Access Compliance Report

Public Rights-of-Way

Intersection ID: 10168	Main Street: ROZZELLES_FERRY_RD	Cross Street: S_GARDNER_AV	Location: S
ADA ID: C4E71AB20144	Ramp Type: PerpDiag	Initial Pass/Fail: Fail	Overall Compliance: No
		Severity Score: 10

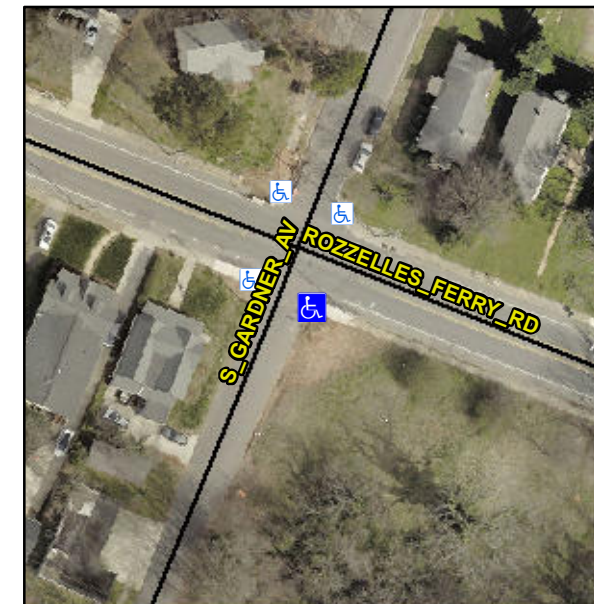
Not Found, R304.5.1, R304.5.3

Compliance	Description	Data	Compliance	Description	Data
N/A	Ramp Length (in)	54.0	Yes	Ramp Slope (%)	6.3
No	Ramp Width (in)	47.5	No	Ramp XSlope (%)	3.5
N/A	Flare Type LT	N/A	N/A	Flare Type RT	N/A
N/A	Flare Slope LT (%)	N/A	N/A	Flare Slope RT (%)	N/A
N/A	Flare Traversable LT?	N/A	N/A	Flare Traversable RT?	N/A
N/A	Landing Length (in)	N/A	N/A	DWS Provided?	N/A
N/A	Landing Width (in)	N/A	N/A	DWS Contrast?	N/A
N/A	Landing Slope (%)	N/A	N/A	DWS Length (in)	N/A
N/A	Landing X Slope (%)	N/A	N/A	DWS Full Width?	N/A
N/A	Landing Curb? (Y/N)	N/A	N/A	DWS Offset (in)	N/A
N/A	Shared Landing?	N/A			
N/A	Gutter Ponding?	N/A	N/A	Gutter Slope (%)	N/A
N/A	Gutter Lip Ht (in)	N/A	N/A	Gutter X Slope (%)	N/A
N/A	Painted X Walk1?	No	N/A	Painted X Walk2?	No
	X Walk 1 Direction	To NE		X Walk 2 Direction	To NW
N/A	X Walk 1 Width (in)	N/A	N/A	X Walk 2 Width (in)	N/A
	X Walk 1 Slope (%)	5.8		X Walk 2 Slope (%)	1.5
	X Walk 1 X Slope (%)	0.9		X Walk 2 X Slope (%)	3.6

Remove & Replace Curb Ramp With Two New Directional Ramps or Equivalent.
